| Project | 8 PILGRIMS LANE NW3 1SL- 2012/5825/P - APPEAL | Project Ref | G1206 |
| Subject | On Grieg Ling 05/02/14 Additional Basement Information and Footing–Undrained–Plaxis Report. | Date | 11/2014 |

Figure 5

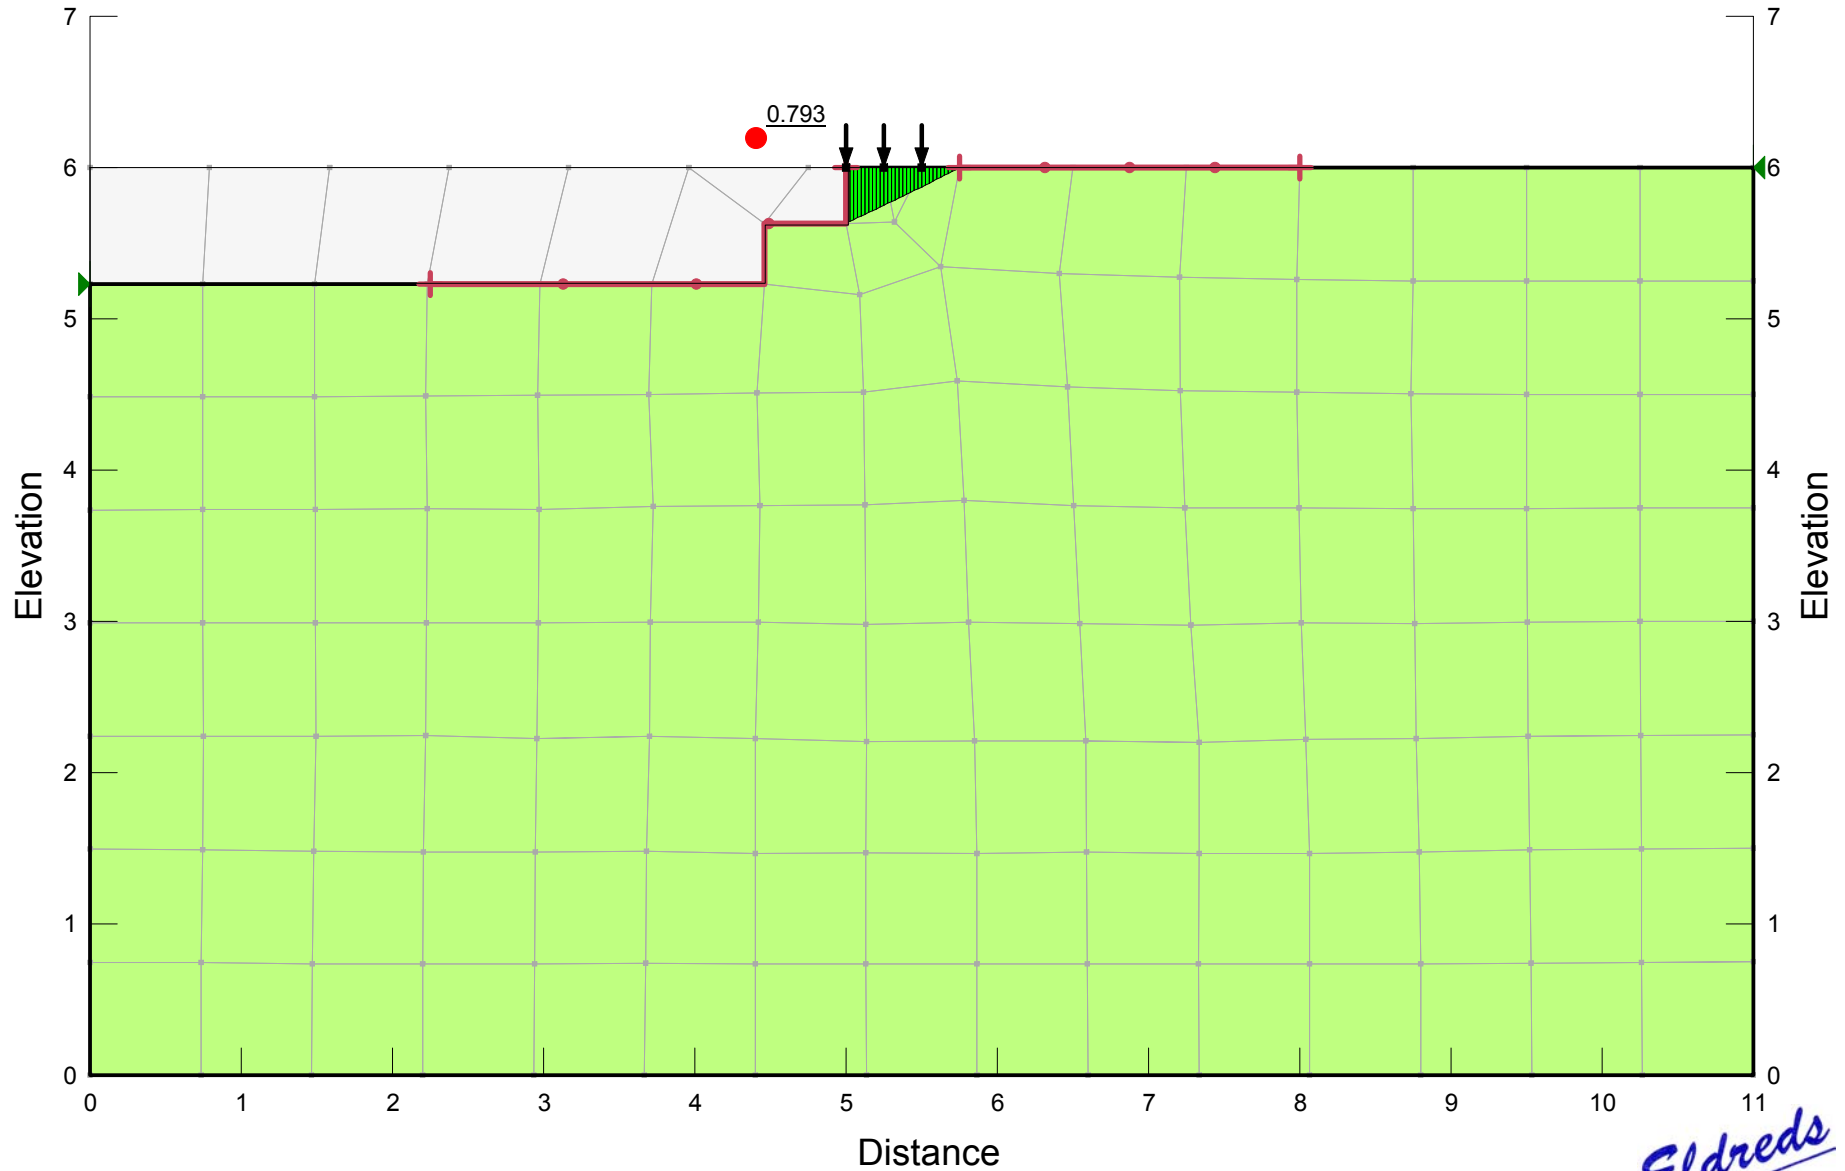
Figure 5 estimates how the stability of the foundation would be immediately affected by the excavation.

Note that this conclusion and the inadequate safety factor of 0.79 shown by Figure 5 are based upon the ground strength of 50 KPa assumed for the Plaxis calculation. The more realistic ground strength value of 30KPa noted above results in a further reduced safety factor of 0.48.

CRITICAL FACTOR OF SAFETY = 0.793 = FAIL
